Management Control Program 5.2

POWERTECH (USA) INC.

Figure 5.7-11: Operational Environmental Monitoring Sites

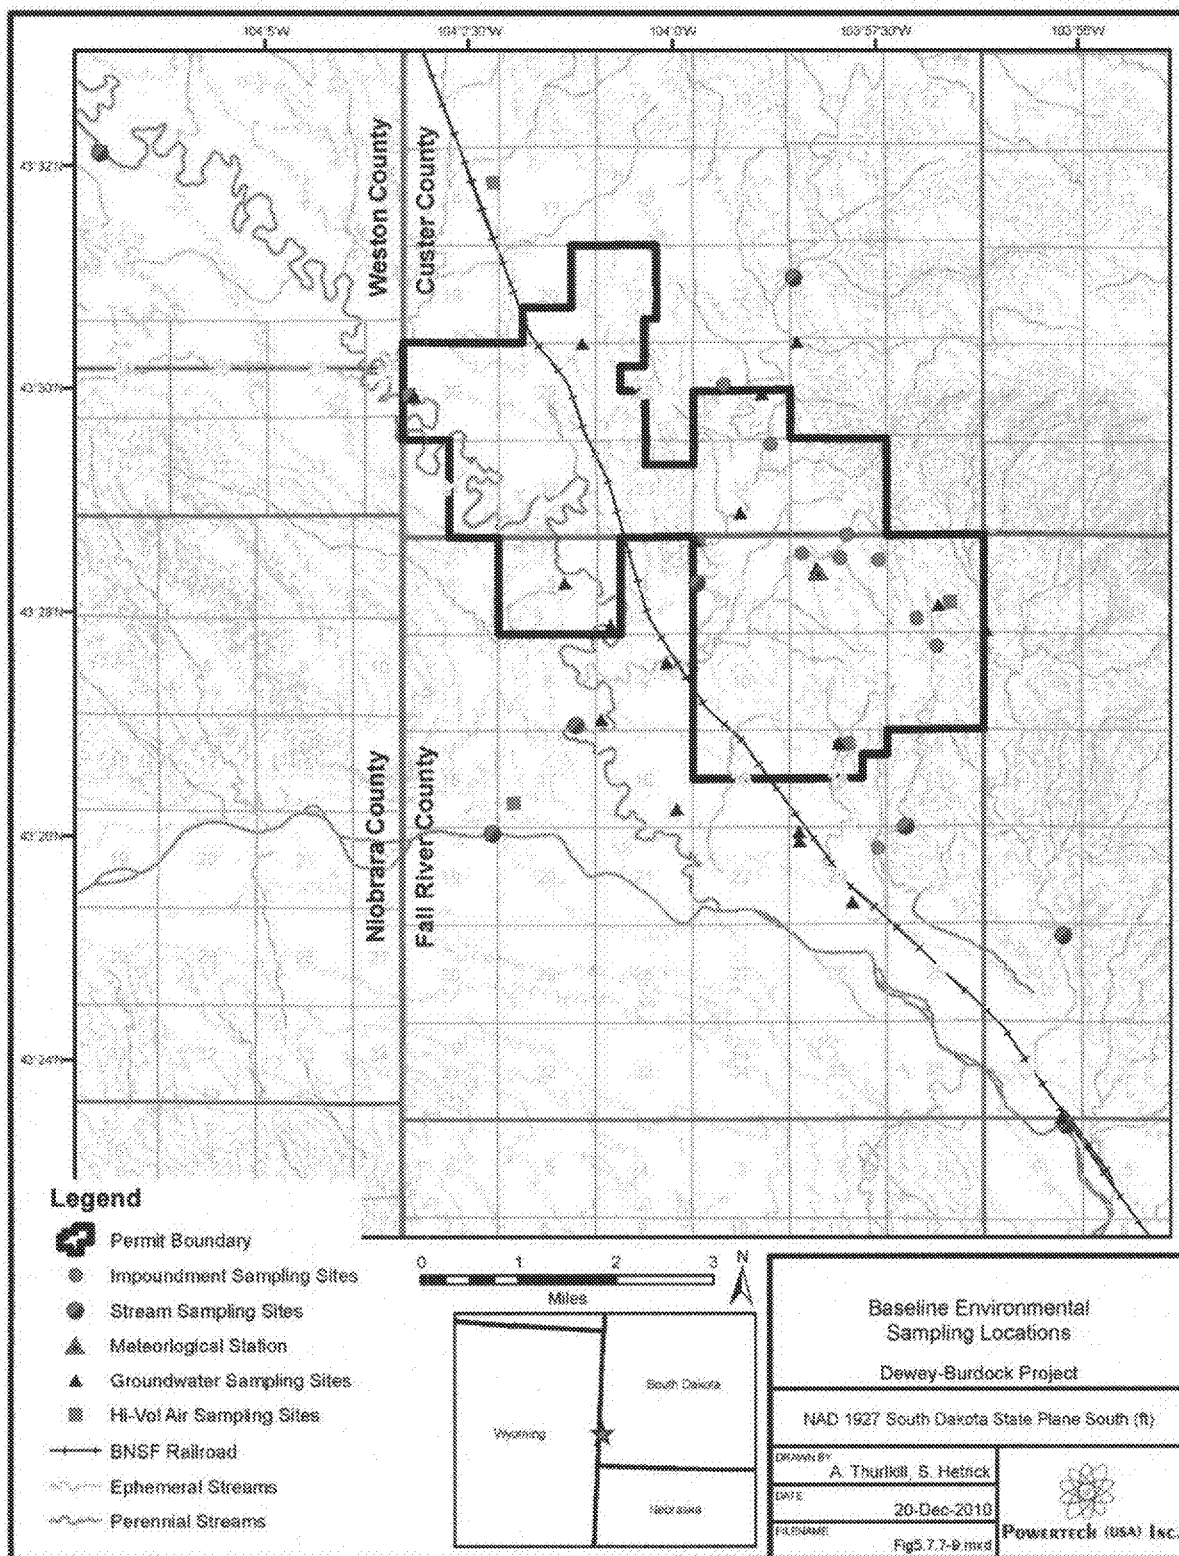
In Section 2.7.3.1 of the TR the applicant identified 48 surface water impoundments. However, in Section 5.7.8 of the TR, the applicant identified only 11 impoundments in its operational surface water monitoring program as shown on Figure 5.7-10 of the TR.

See TR_RAI-Response Response 5.7.8-9 for (Figure 5.7-11) the scale of the map has been adjusted to depict all surface water sampling locations upstream of PAA and downstream of PAA.
